Pre Bid Technical Clrification No.2 dated 02.05.2025 to NIB No.477 dated 26.02 2025 for EPC execution of EM Works of Heo HEP

Developer:	HEO HYDRO POWER PVT. LTD.		
Project:	HEO H.E.P. (3X80MW)		
	ARUMACHAL PRADESH, INDIA		
Title:	VALVE HOUSE		Project no IOS-1776
	PLAN AND SECTIONS		
Scale 1:	Dimensions in mm		
Drawing no	Drawing no		Rev. 1
	Customer		
			1275-CD-0408

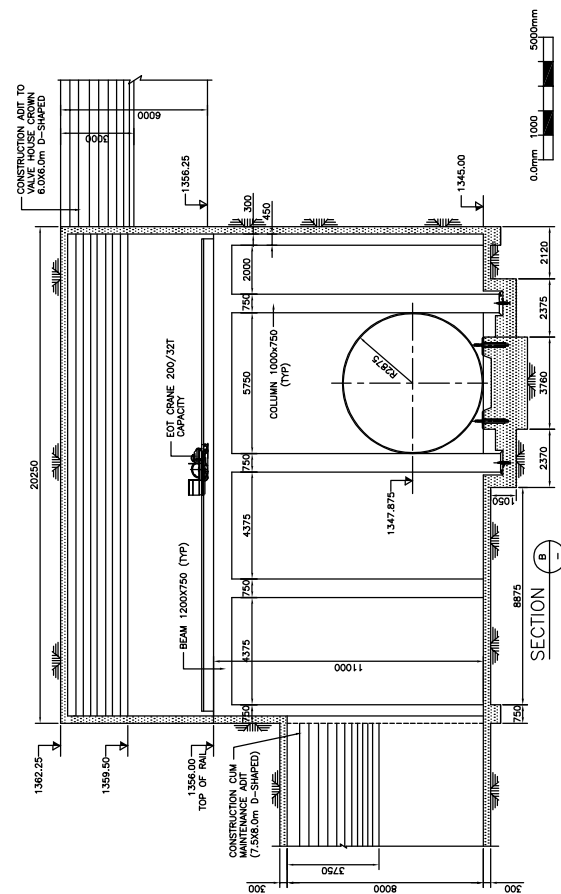
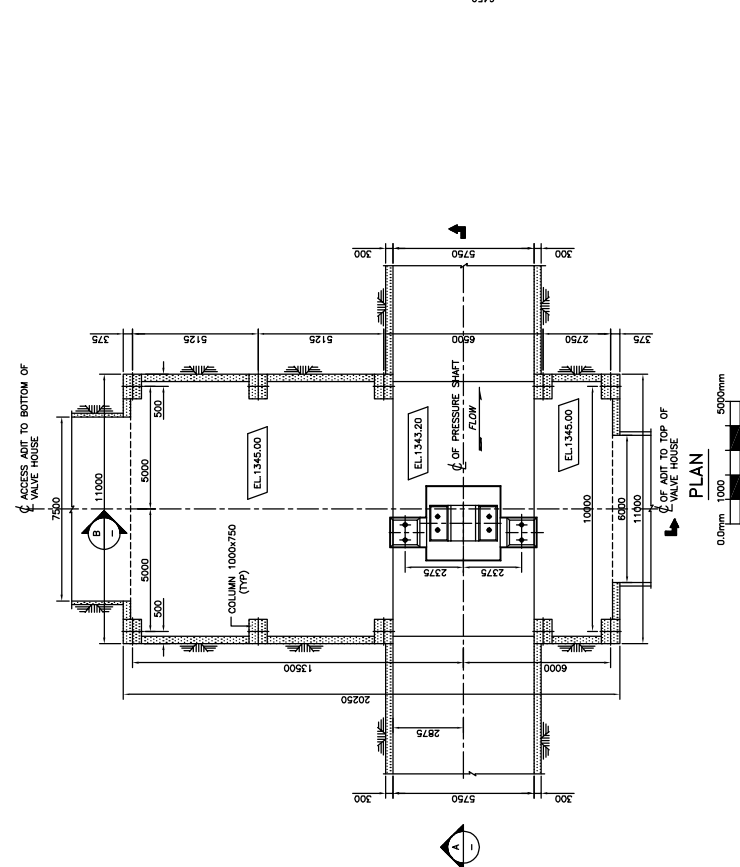
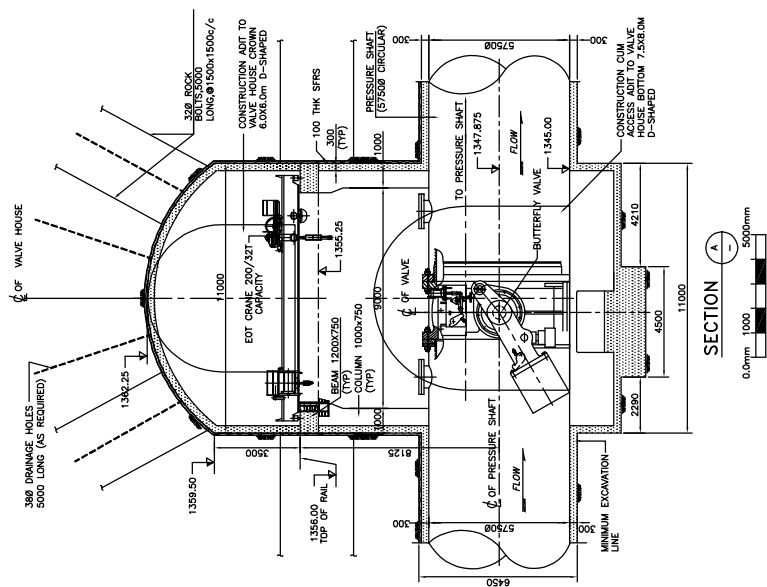
BOQ_256324 Item Rate BoQ	BoQ1	28	210/32/5 T - 1 set for Power House , 200/32 T -1 Set for Penstock valve house		
41	Volume 2 ,Section-II, M5	4	Note of Clause 4.3	Point hooks with shanks for general engineering purpose.	As IS:3815 is withdrawn the applicable standard shall be IS 15560.	The latest edition of IS standards relevant for the crane capacity/rating shall be applicable.
42	Volume 2 ,Section-II, M5	2	4.2.2	The general arrangement of the crane shall be in accordance with the BF Valve House layout drawings enclosed and as described in the specification at various places	BF Valve House layout drawings is not available in tender drawings. Kindly furnish tender drawing.	The ratings and other details of the BF Valve House Crane is already given in the PTS and the same appears to be sufficient for tender estimate purpose. The Civil Drawings shall be provided when finalized by the Civil Contractor. However, the drawing as per the DPR is enclosed for reference as Annexure-I.
